# ADA Curb Ramp New Construction Inspection Form (Perpendicular)

Nw 291 st

23885.56

Nw fair st

## PERPENDICULAR RAMP (PR)

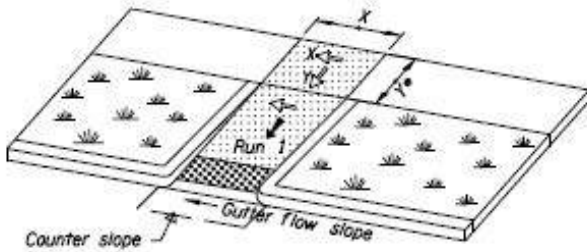
Tool joint in turn space rr1 icrr
